13 March 2015

The General Manager  
Lane Cove Council  
PO Box 20  
LANE COVE NSW 1595

**Draft St Leonards South Masterplan  
Submission for 'Centre Berry East/Holdsworth West' Group**

St Leonards South Masterplan, Figure 6.10 Heights and Envelopes, page 69

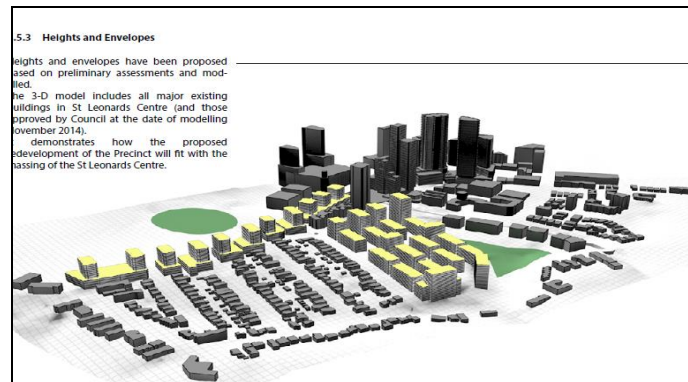
According to the modelling provided in the masterplan, the area could look like the following and suggests that more could be done to improve an even approach along the corridor.

It may be better to provide slender, taller tower blocks tapering down, transitioning in built scale towards the River Road boundary. This would provide more appropriate density and renewal and may allow for larger open spaces between to benefit solar access, utilize views and create the best amenity.

The form proposed is not considered well justified. It is homogenous and unimaginative and does not reasonably address interface impacts.

The proposed buildings when constructed will appear as a close-knit series of wide monolithic 'blocks' along a ridge line, which do not respond well to the existing/planned fabric.
